## IDAP REPORT

<b>Property:</b>	7 Mount Street STRATHFIELD Lot: 23 in DP: 5836 DA 2021/256
<b>Proposal:</b>	Construction of an attached double car garage in front of an existing dwelling house.
<b>Applicant:</b>	Everising Pty Ltd
<b>Owner:</b>	Z Huang and Y Zhou
<b>Date of lodgement:</b>	12 October 2021
<b>Notification period:</b>	15 October 2021 to 20 October 2021
<b>Submissions received:</b>	Nil
<b>Assessment officer:</b>	L Fanayan
<b>Estimated cost of works:</b>	\$80,000.00
<b>Zoning:</b>	R2-Low Density Residential - SLEP 2012
<b>Flood affected:</b>	Yes
<b>RECOMMENDATION OF OFFICER:</b>	<b>REFUSAL</b>

Figure 2: Site Plan

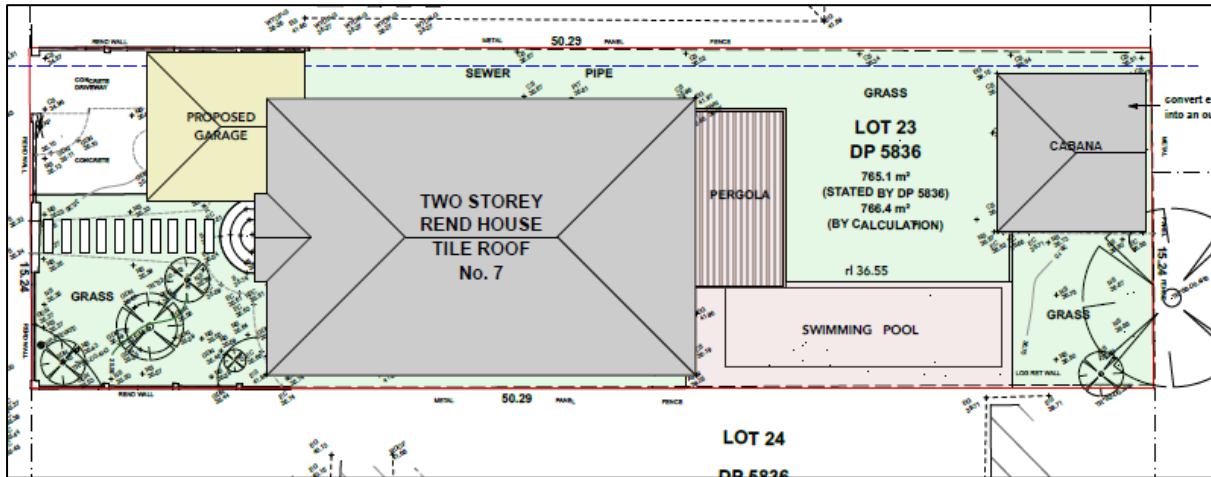
The dwelling on the property is currently setback 11.1m from the front boundary. The proposed double garage has a 5.573m setback from the front boundary for the width of the garage. This variation is not considered to have merit given the reduced setback negatively impacts on the streetscape, does not maintain the desired setback from the street and infringes upon a defined street edge. This is a 38% variation from the development control and generates additional bulk which is not considered appropriate with regard to the site and surrounds. This proposal does not reflect the desired character for the area under the SCDCP 2005.

The site has an existing double story dwelling with a 1.1m side setback on the eastern boundary and 2.7m setback on the western boundary which is utilised as access to the rear yard located garage. The proposed development reduces the western boundary to 0.5m, thus creating a non-compliance with the combined setback of 1.6m (10.5%), this is a 52.5% variation and is not supported. Further, non-compliance occurs as the minimum side setback of 1.2m is not achieved on the western boundary.

The proposed double car garage visually dominates the street façade of the dwelling. The garage is not recessed behind the building line, the proposed driveway is 6.02m at the building line and is not setback from the side boundary by 0.5m.

Further, the reduced front setback does not provide adequate and convenient on-site car parking. Vehicles do not have to enter and exit in a forward motion, regardless, from the planning perspective the driveway area in front of the garage is considered too small to provide well-functioning access to the double garage without expanding the driveway width at the boundary. As such, the proposed variations to the garage location and driveway design are not considered reasonable and not acceptable.
